Questions and answers from 150 to 174.

**SCHEMATIC DIAGRAM 1:
VERTICAL SECTION ACROSS THE
MAIN EXHIBITION ROOMS**

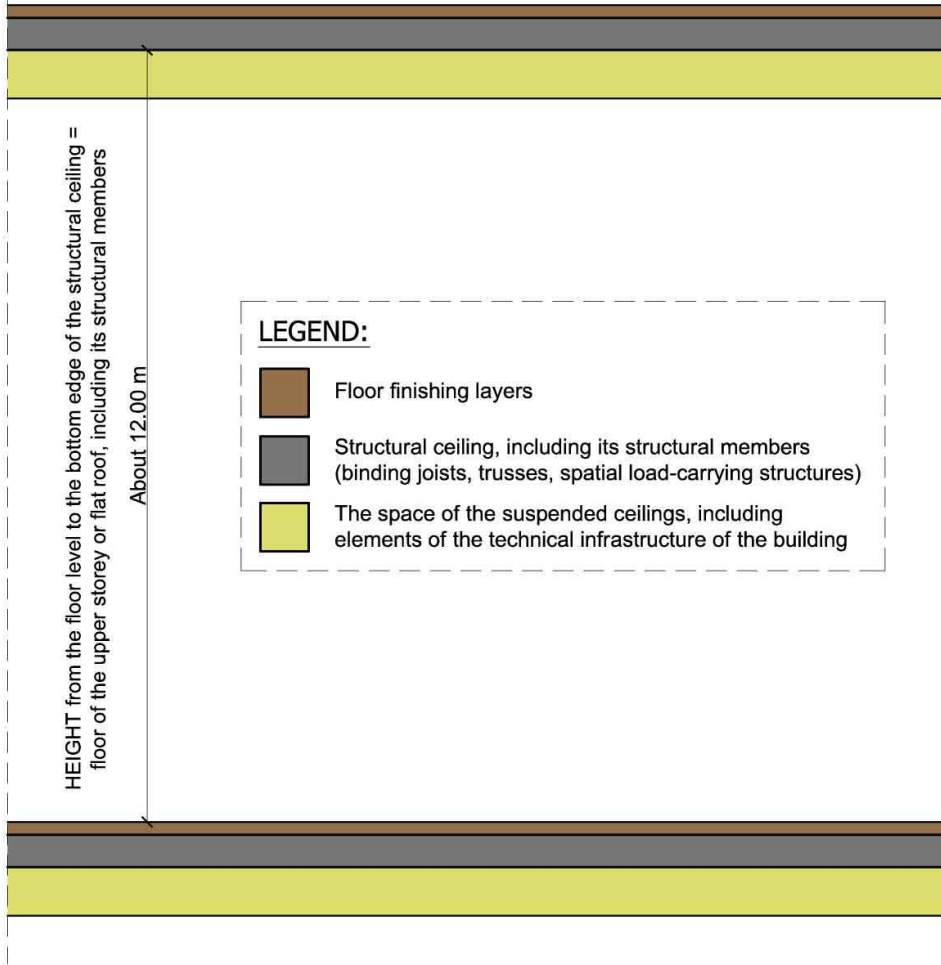
161. We realize you have answered more than once the question about the height of the permanent exhibition (as well as the height of the temporary exhibition, and the storage rooms - calling it "net height") - but would it be possible to answer also graphically? Meaning a drawing scheme, stating what is considered as "net", "proper ceiling", etc. and with dimension lines showing us exactly where we are to have 12 m.

Point 3.7.4.D of the Rules of Procedure reads that: „The height of the exhibition rooms in the permanent exhibition area should be approximately 12 m counting up to the lower edge of the structural floor of the upper story or the flat roof, including its structural components (binding joists, trusses, spatial load-bearing systems, etc.) [...]. The temporary exposition rooms should be no less than 4.80m high net [...]”. Moreover, the Organiser informs that if the structure of the ceiling enables fitting elements of the building’s technical infrastructure for which the envisaged technical space is reserved, in between the ceiling structural members, the overall height can be reduced, as appropriate.

The height of the exhibition rooms should be adopted in accordance with the schematic drawing below:
